**Village of Weston, Wisconsin**

**Meeting of the PLAN COMMISSION**

**Monday, October 12, 2020 @ 6:00 P.M.**

**PHOTOMETRIC SITE PLAN**  
**PATRIOT AUTO**  
**WESTON, WI**

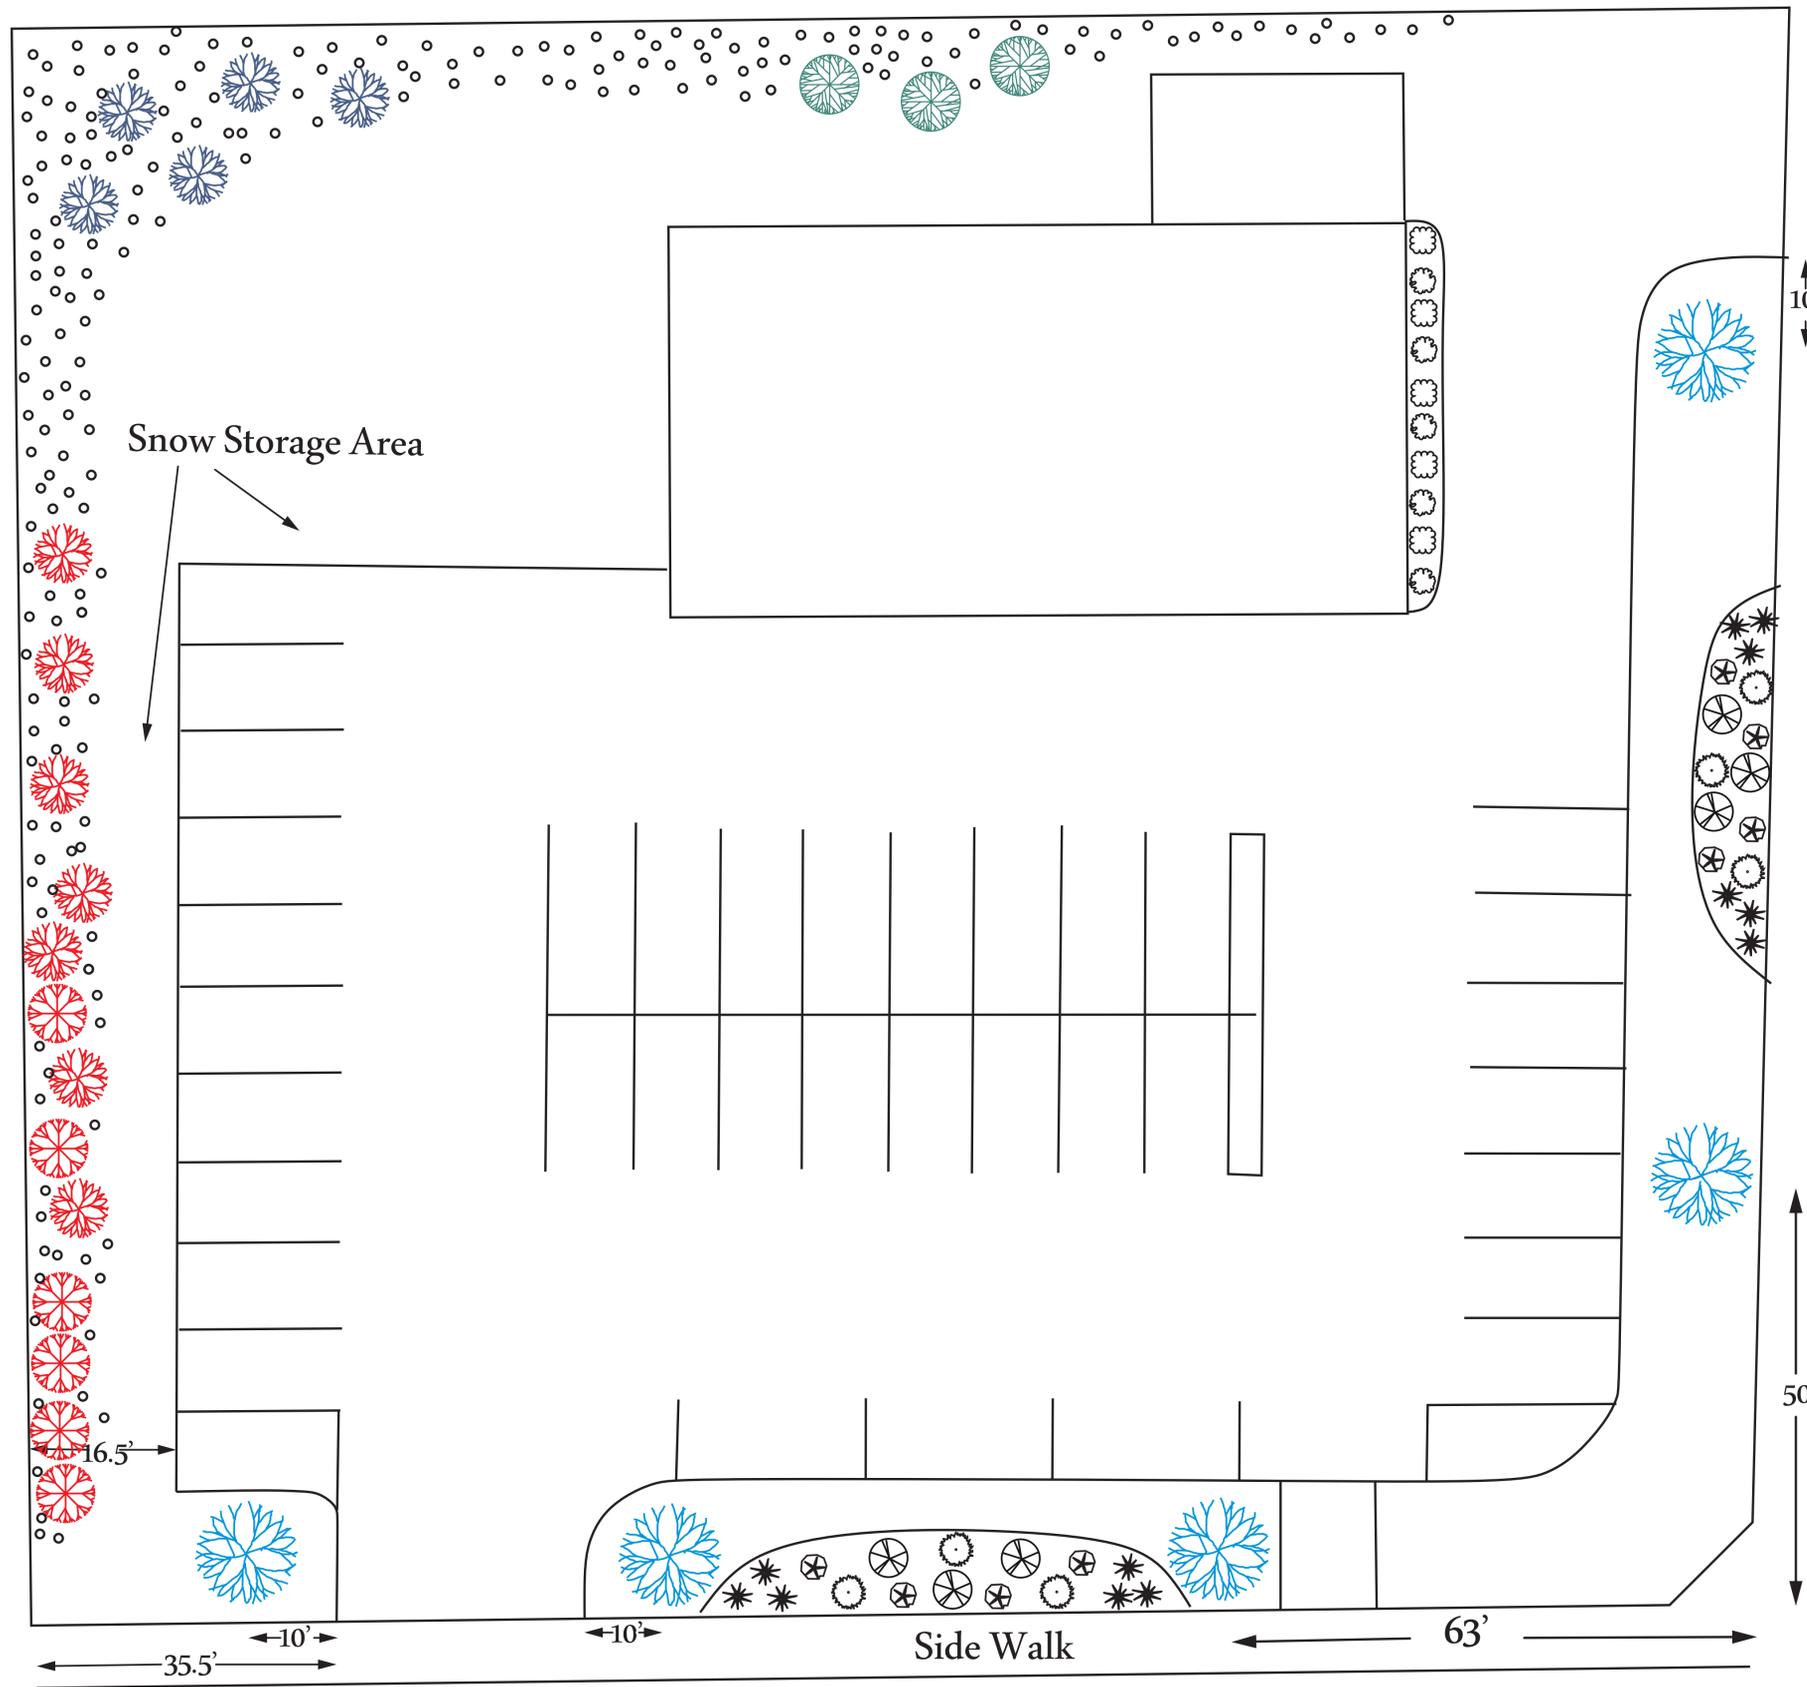
Pinsonneault stated he agrees with Condition #1. He questioned with Condition #2, if the whole lot has to be lit? Higgins stated the code requires adequate lighting, and how the parking lot should not be at 0, and full photometrics needs to be supplied. Gau stated if Pinsonneault wants to be there then he needs to comply and work with staff. Higgins stated PC needs to make a decision on the elevations. Pinsonneault stated the elevations meet code. Maloney and Gau wants to see color. Higgins read the techniques that are required under the approved building materials section of the code. This section also needs to be met regardless of the building materials section.
